November 24, 2021

Subject: George Hall Elementary School HVAC Replacement
San Mateo - Foster City School District
Aedis Project No. 2021005.02
DSA Application #01-119523

ADDENDUM NO. 1

SHEET
REF. SHEET MP2.03
AD1-MP2.03b

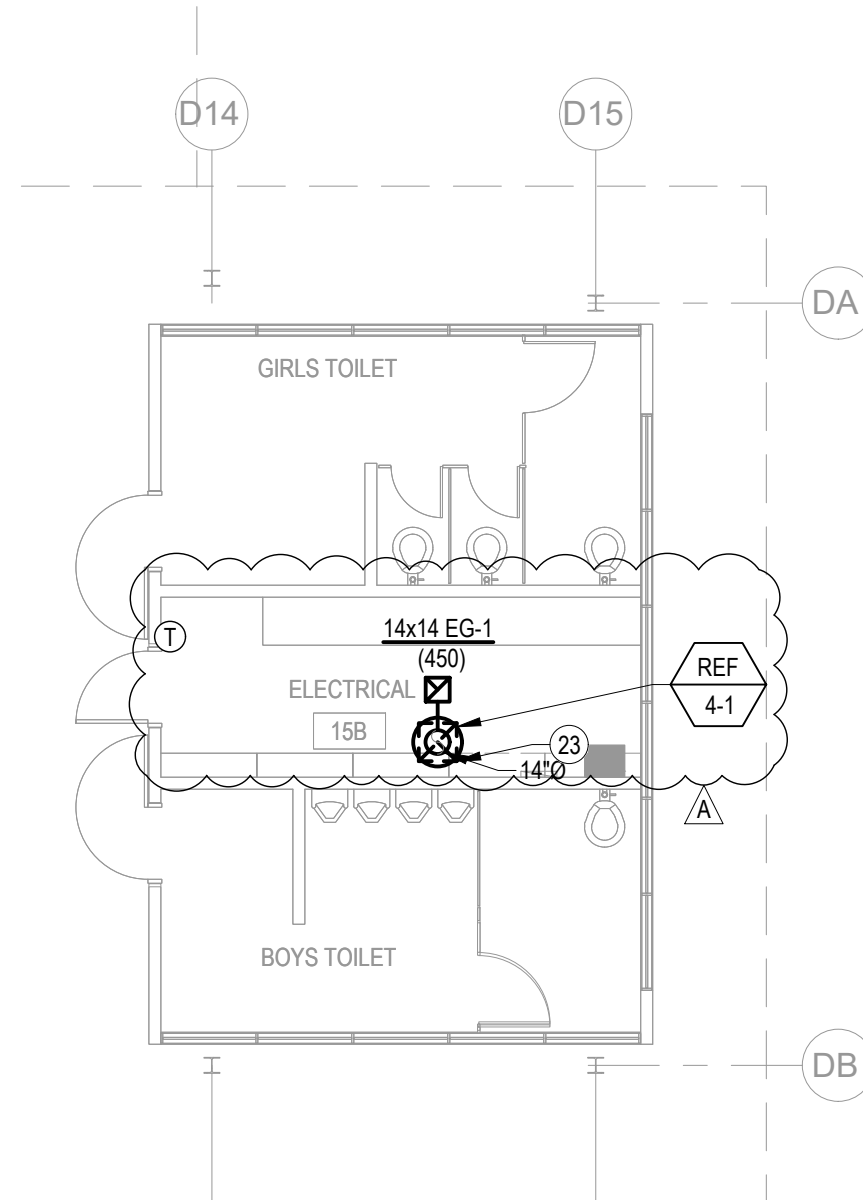
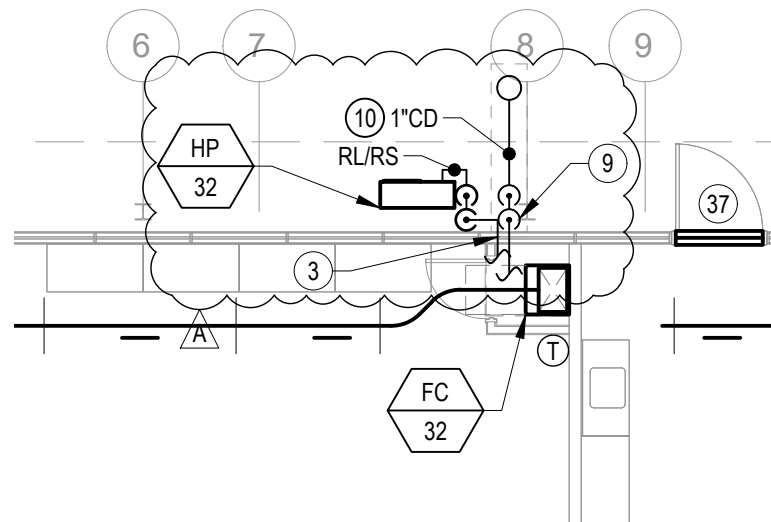
Add: Roof exhaust fan per AD1-MP2.03a
Revise: General Notes #4 & #5 per AD1-MP2.03a
Add: New Sheet Note #23 per AD1-MP2.03a
Add: Roof exhaust Fan per AD1-MP2.03b
Add: New Sheet Note #23 per AD1-MP2.03b

GEORGE HALL ELEMENTARY SCHOOL - HVAC REPLACEMENT	
		SAN MATEO-FOSTER CITY SCHOOL DISTRICT	
387 S. 1st Street, Suite 300 San Jose, CA., 95113	tel: (408) 300 - 5160 fax: (408) 300 - 5121	FILE NO.: 41-26	SHEET
		APPL NO.: 01-119523	REF. SHEET MP2.04
		JOB NO. 2021005.02	AD1-MP2.04b
		DATE 11/19/2021

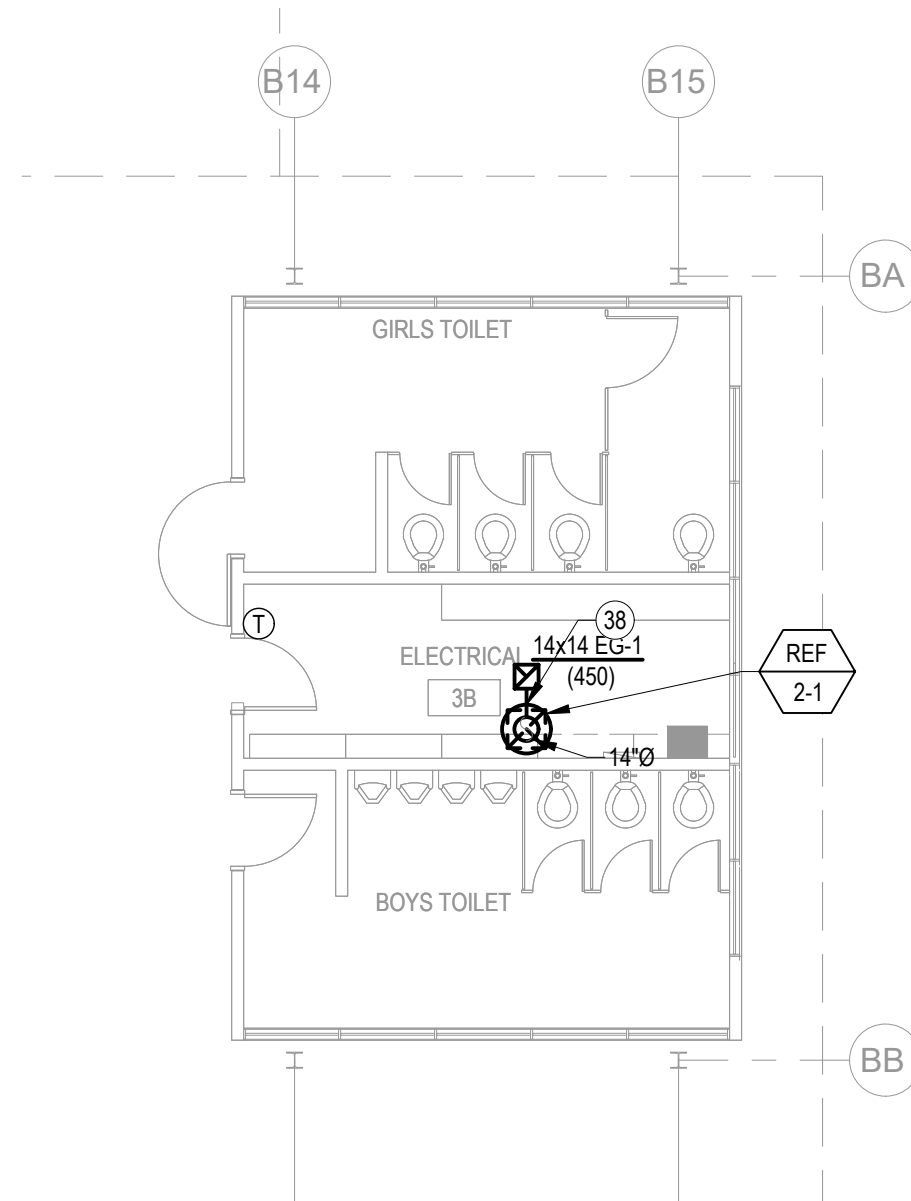
Revise: Location of HP-32 per AD1-MP2.04a
Revise: General Notes #4 & #5 per AD1-MP2.04a
Add: Dimension per AD1-MP2.04a
Add: View 5/AD1-MP2.04 Partial Floor Plan - Wing 2 - New – Mechanical & Plumbing per AD1-MP2.04b
Add: New Sheet Note #38 per AD1-MP2.04b
Add: Exhaust Fan per AD1-MP2.04c

16 EXHAUST FAN MOUNTING

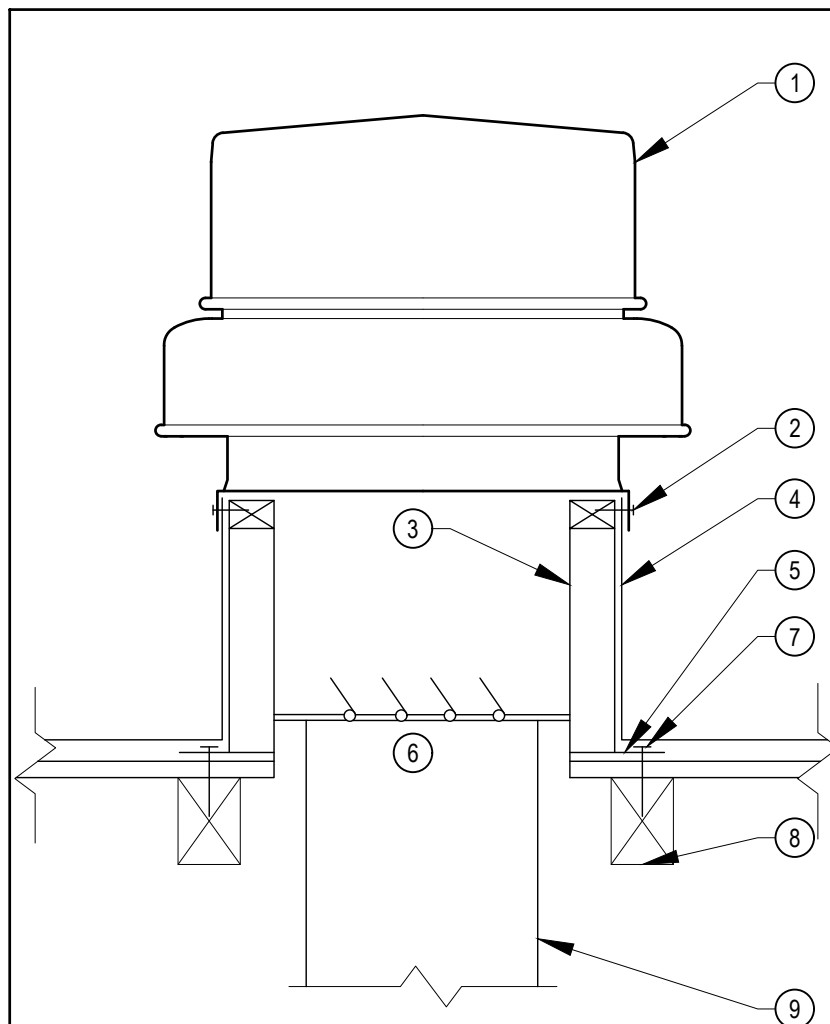
Revise: Detail 4 per AD1-MP6.01
Add: Detail 16 per AD1-MP6.01

AD-1
E1.1

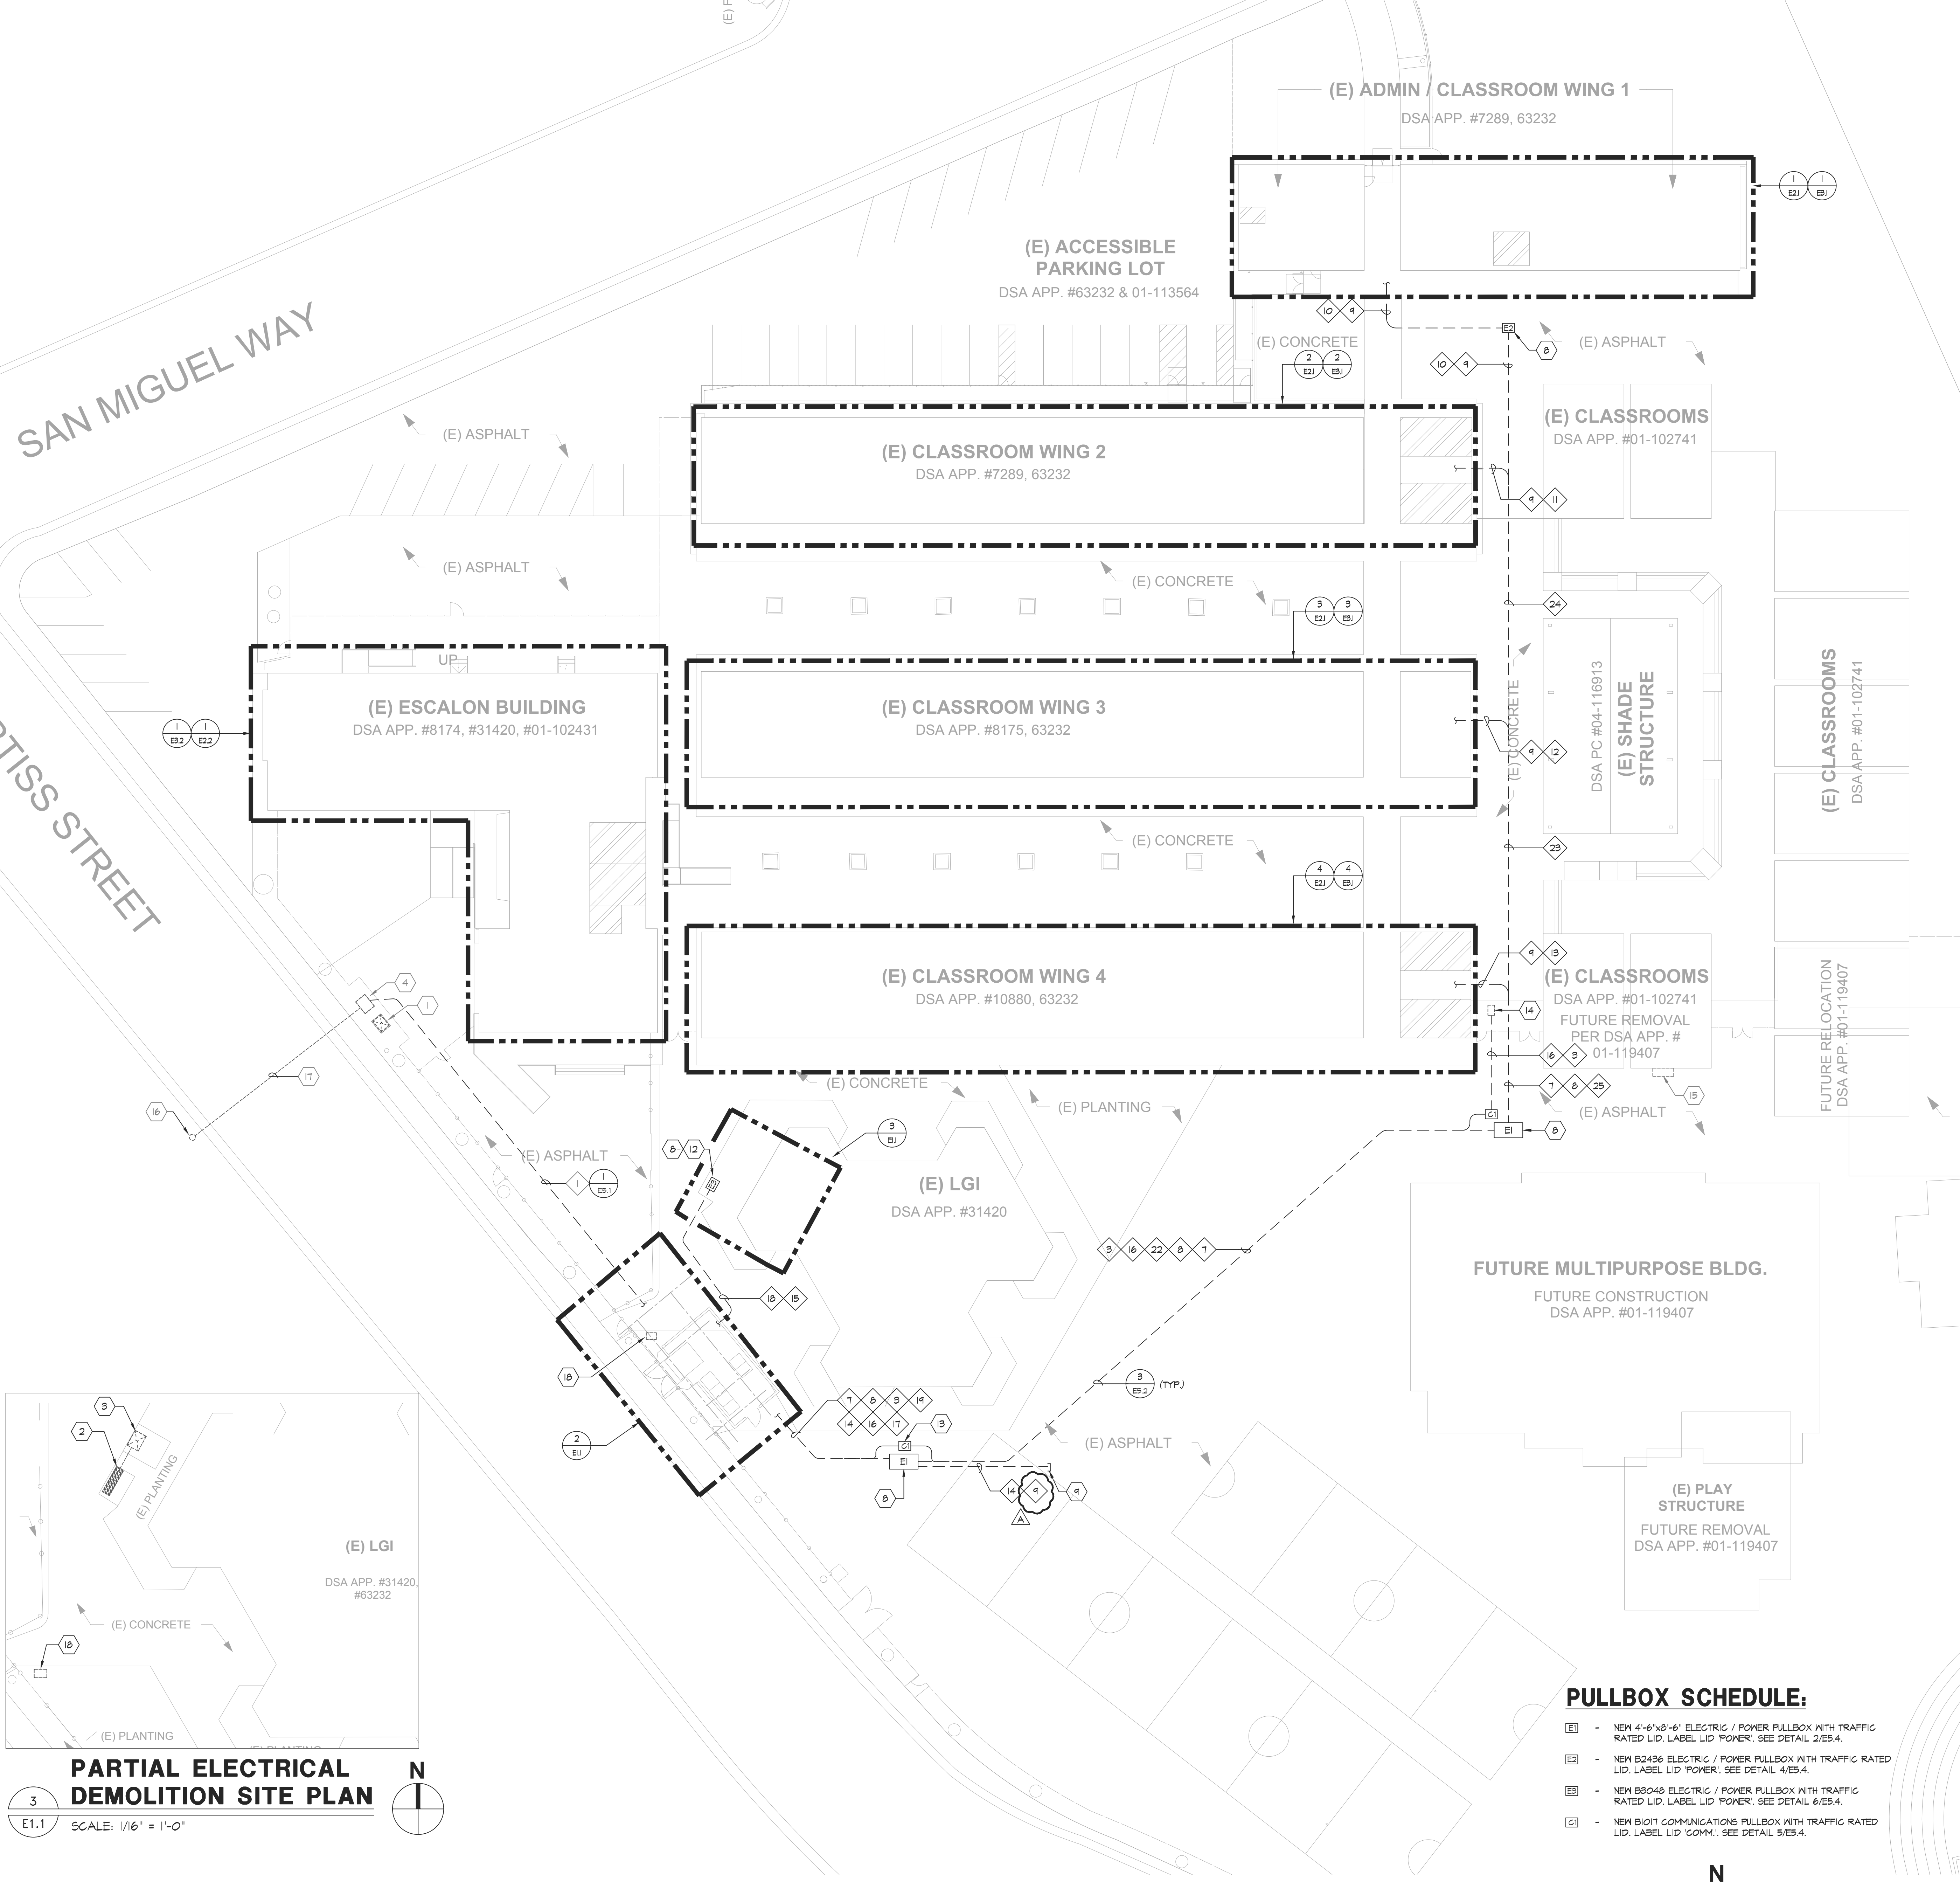
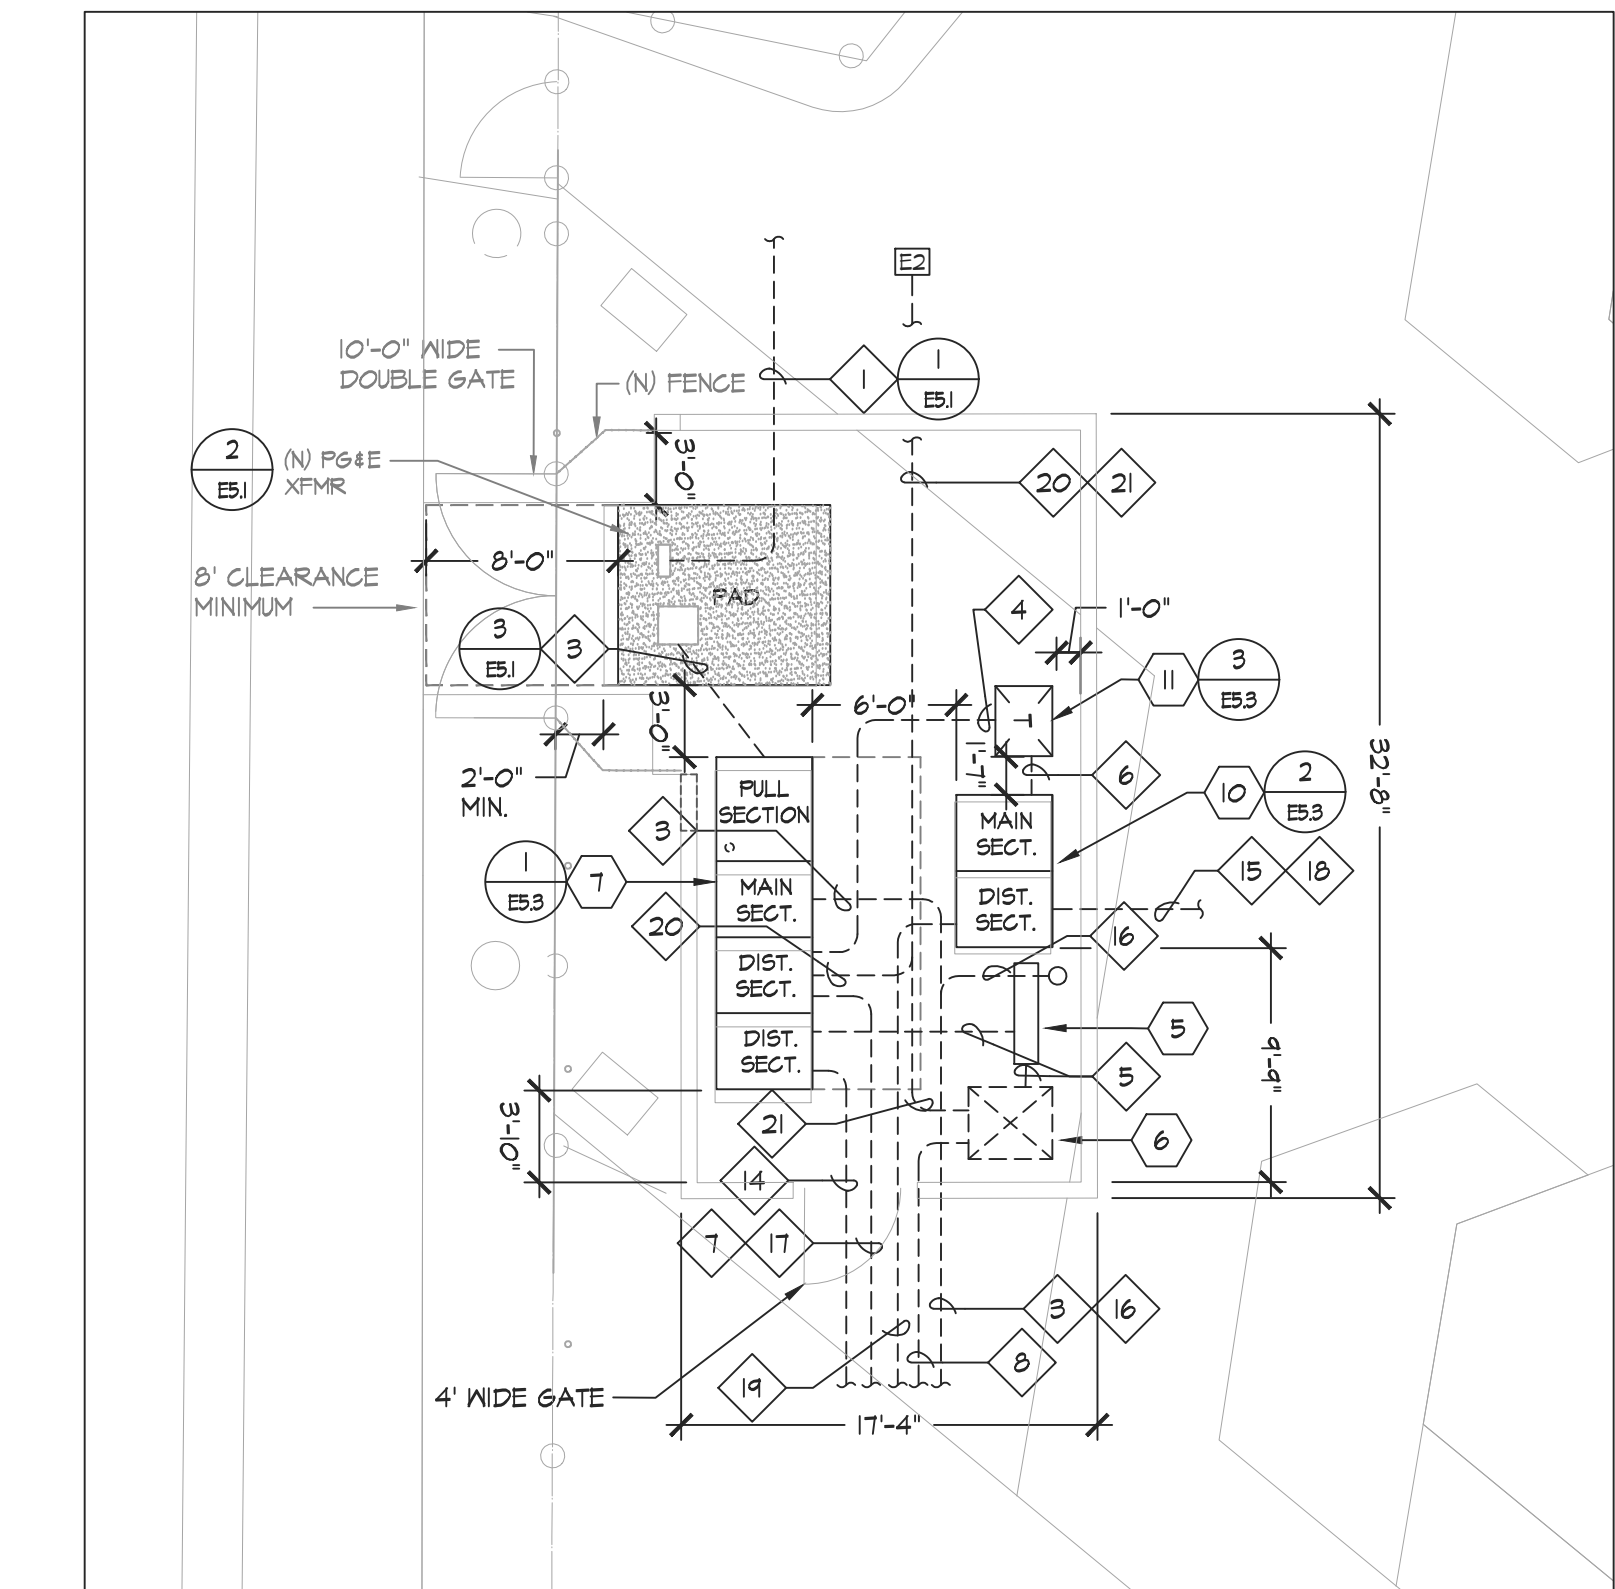
Revise: Conduit Tag #8 per AD1-E1.1

Revise: Conduit Schedule #8 per AD1-E1.1
